- 12/19/18 CK - COMPLETED DESIGN FOR CLIENT & CITY REVIEW.
- 02/18/19 CK - UPDATED PER CITY REVIEW COMMENTS.

Uintah View Estates Improvement Plans

OGDEN CITY, WEBER COUNTY, UTAH
DECEMBER 2018

Grading & Drainage Plan

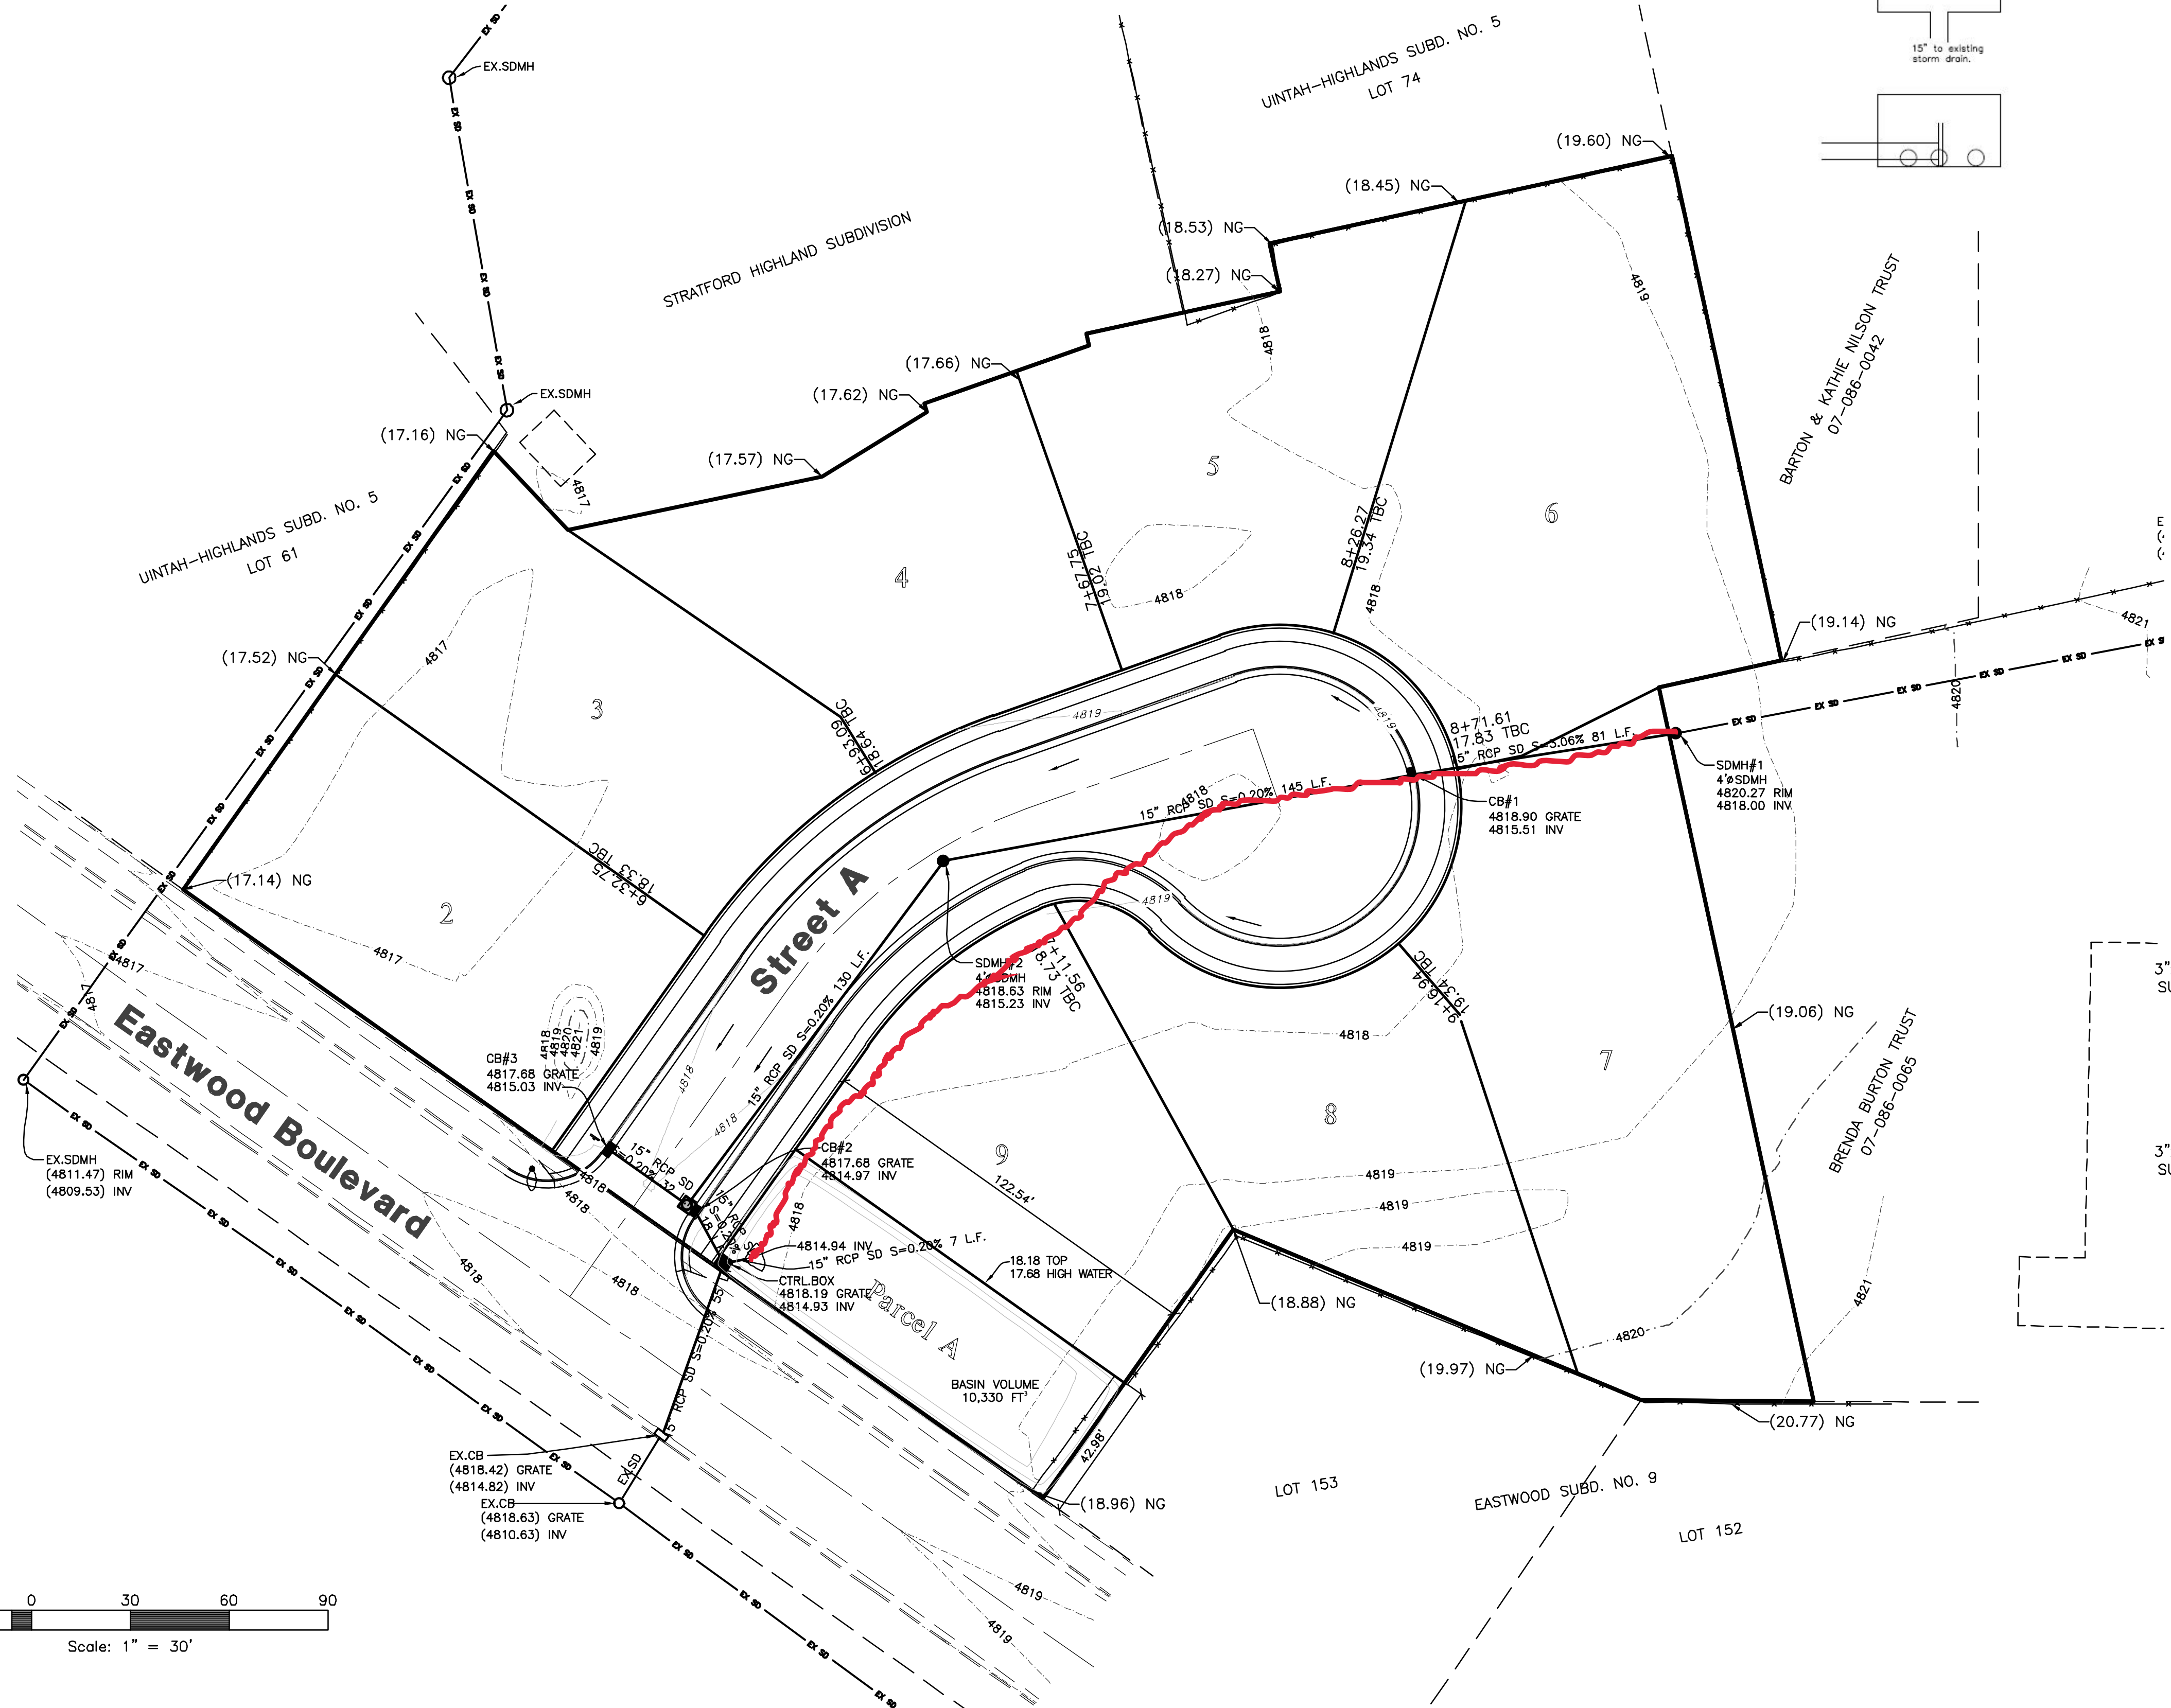
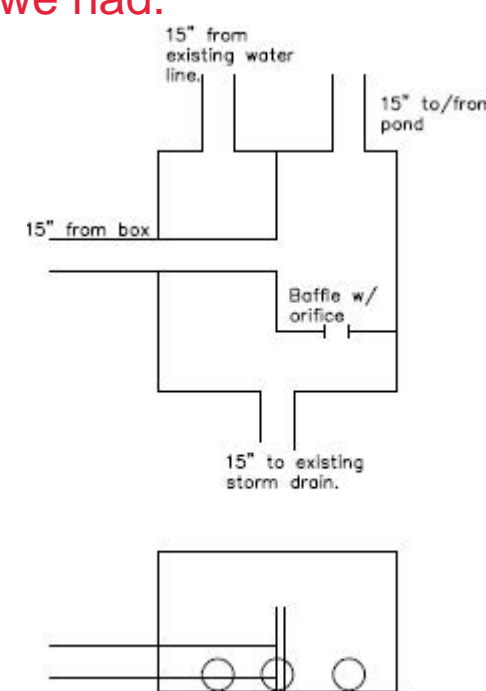
Is there a way we can bypass or separate the storm water that is coming in from the east of the subdivision? And create a box that allows the water collected from the road to be able to flow into detention pond. But allows the water from the east to continue through? The following is an idea that we had.

If it is something like this, there would not be a need to have a combo box at catch basin #2.
